**NOTICE OF ADDENDUM
 ADDENDUM NO. 1**

**CONTRACT NO. 8301
 Reetz Road and Altem Circle Resurfacing Assessment District - 2019**

Insert Sheets U1-U4 (Revised 2-26-2019)

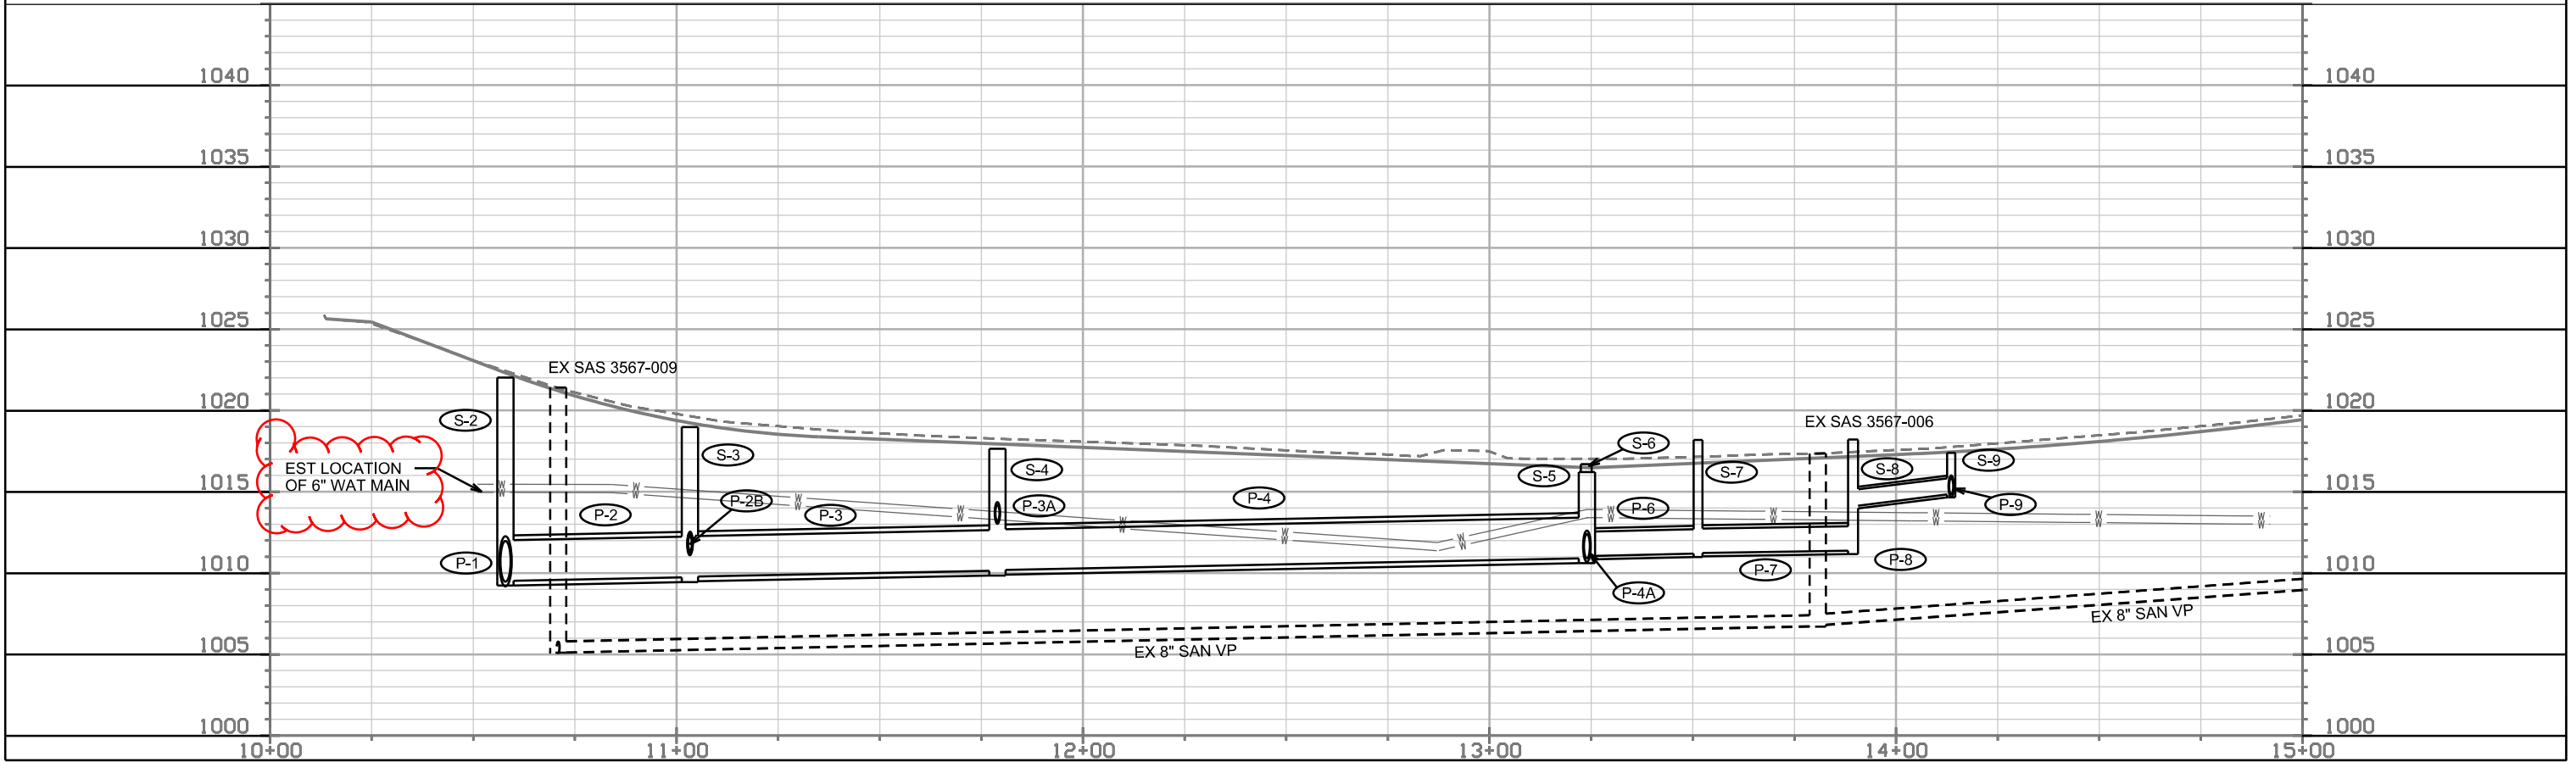
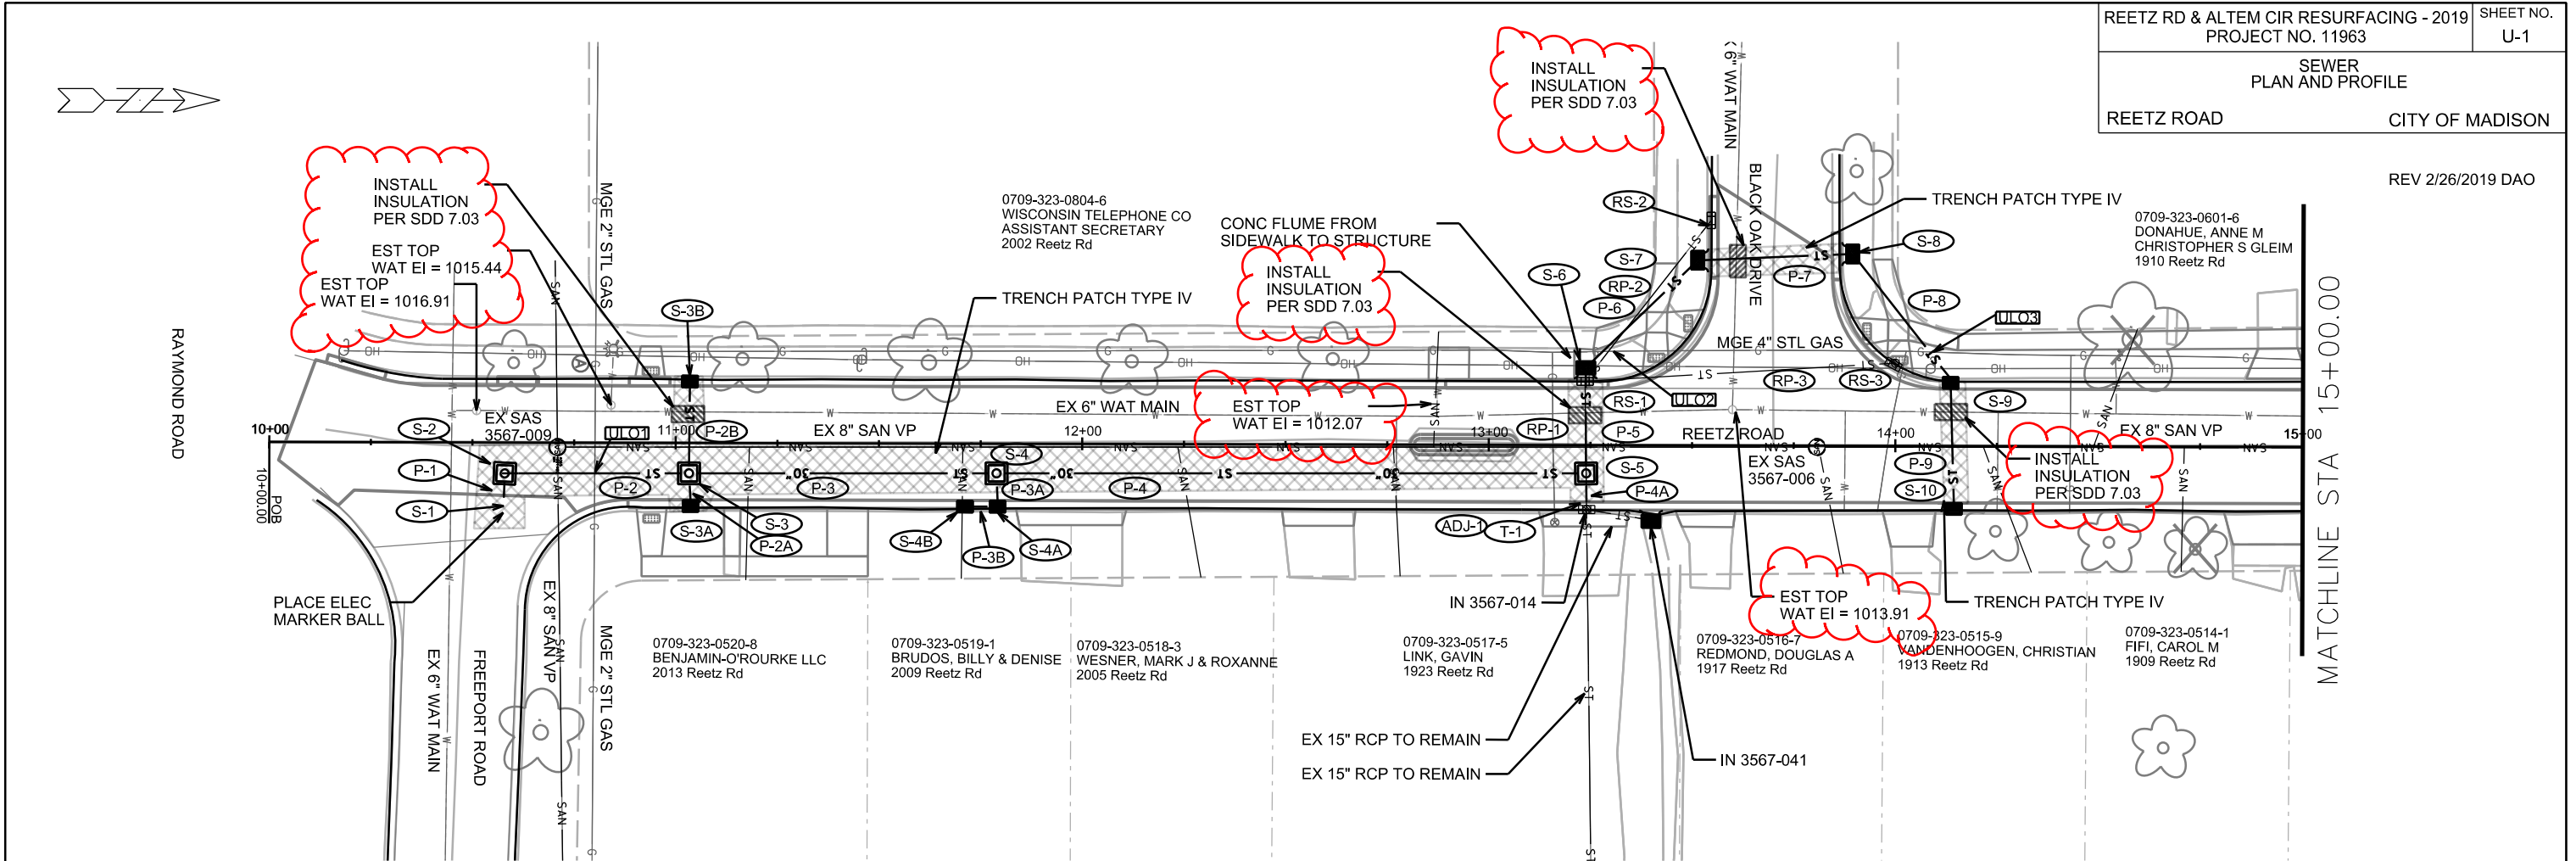
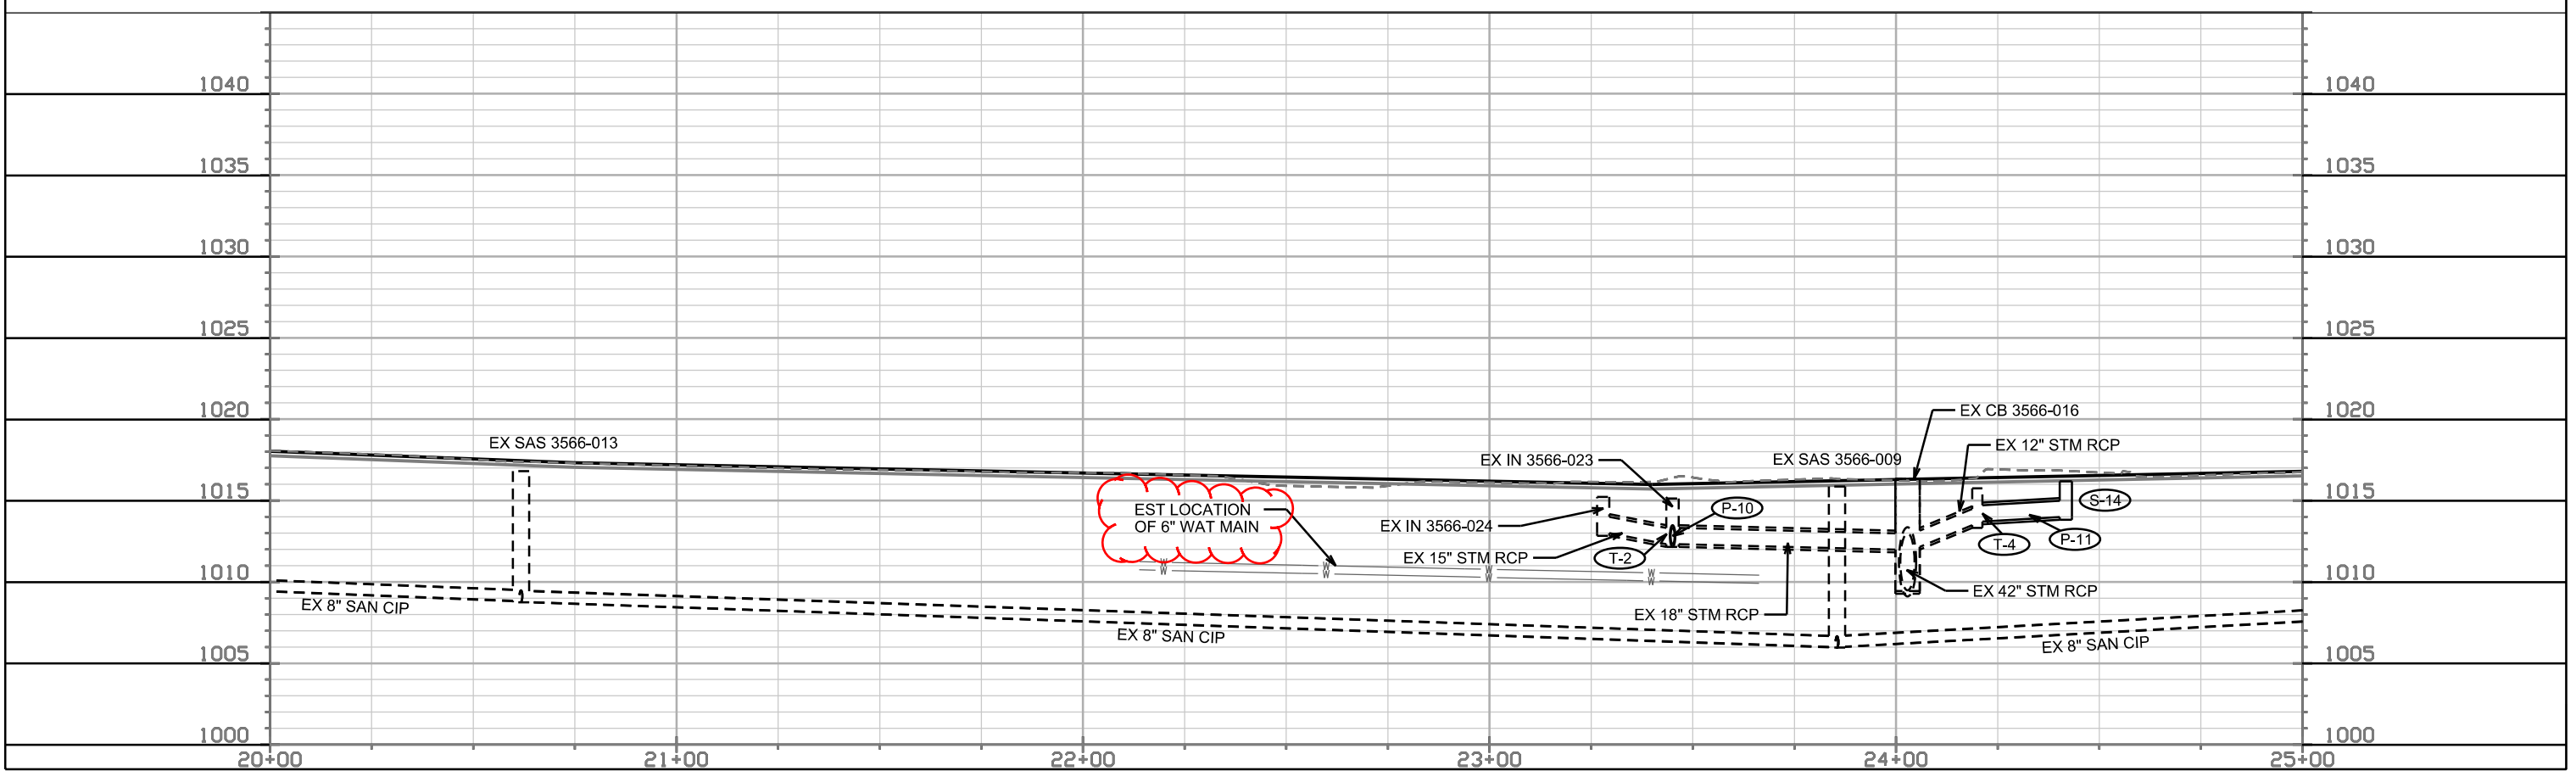
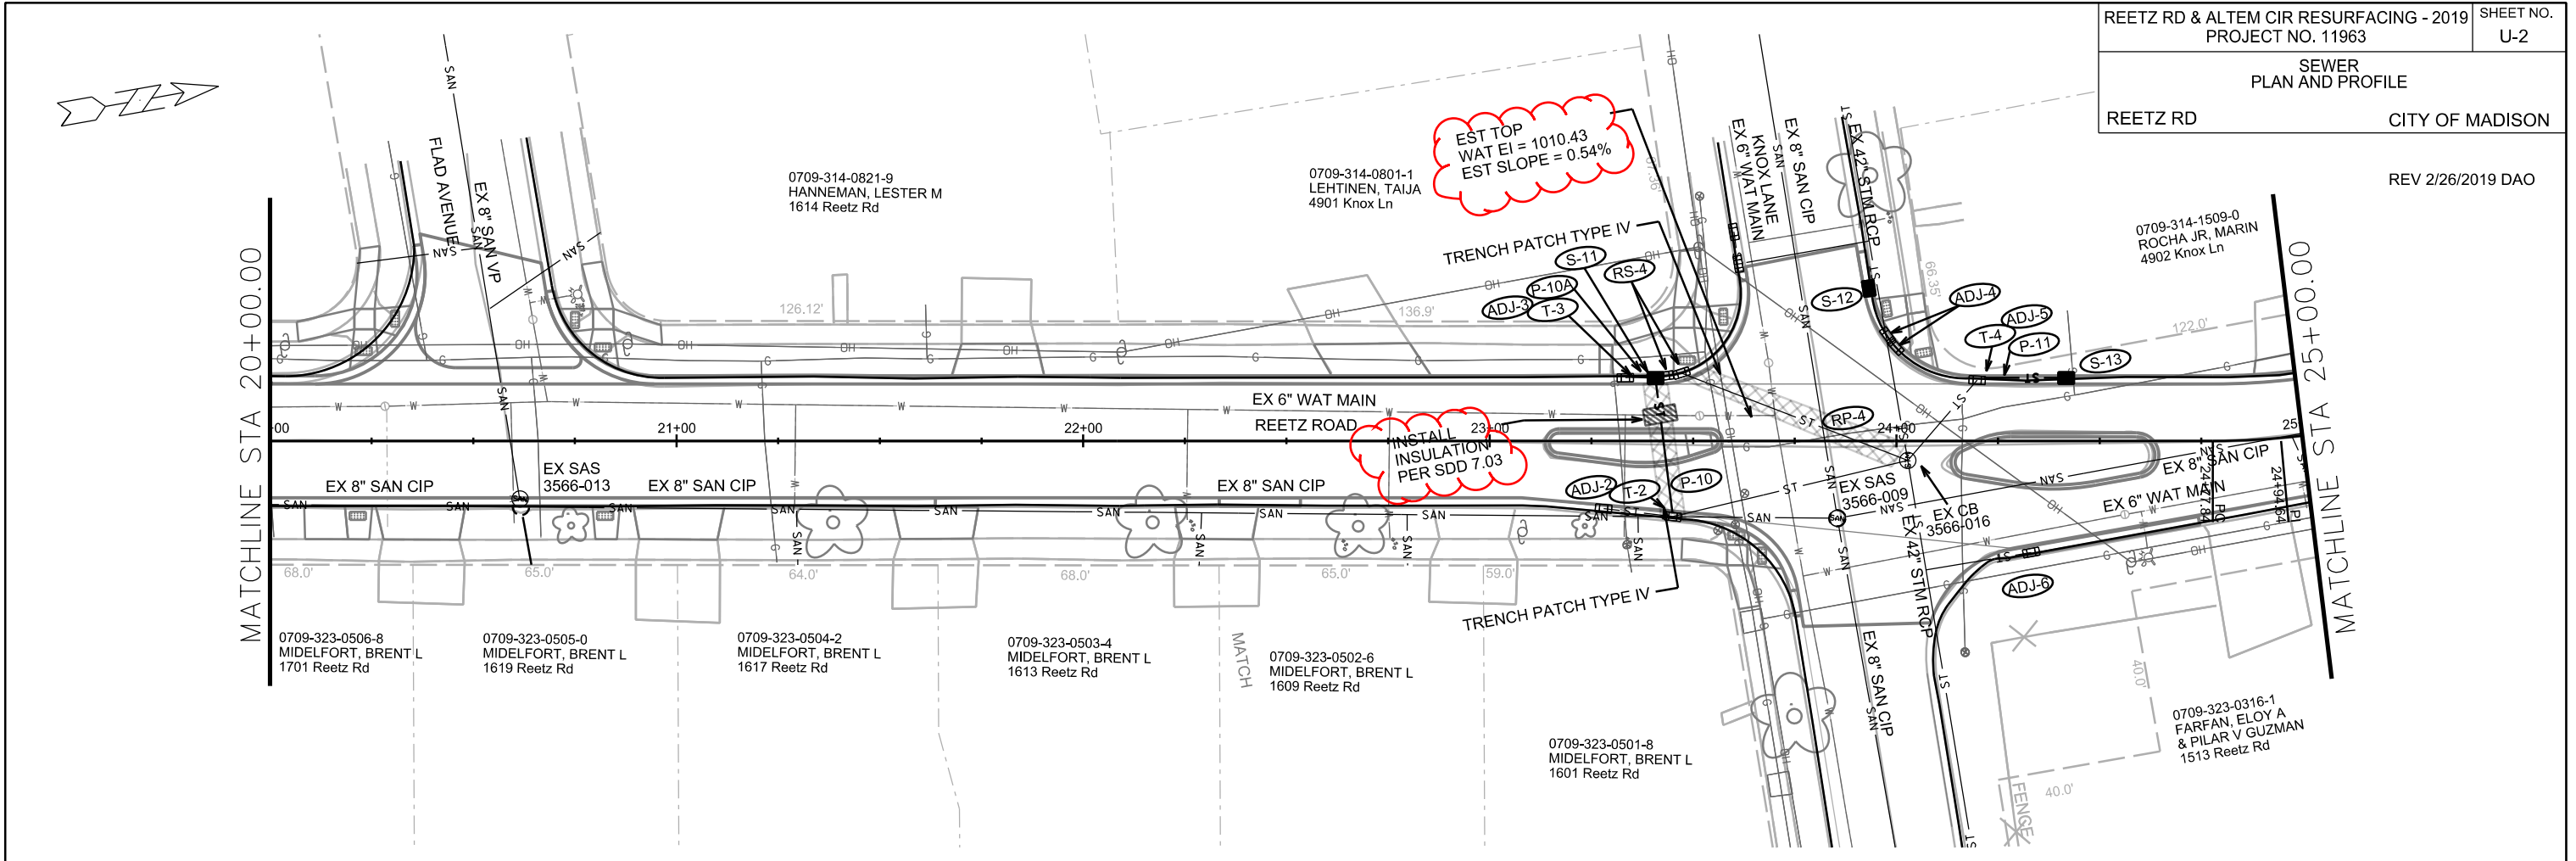
Added insulation between storm pipes and storm structures at the existing water main. Pipe inverts adjusted to avoid conflicts with water main.
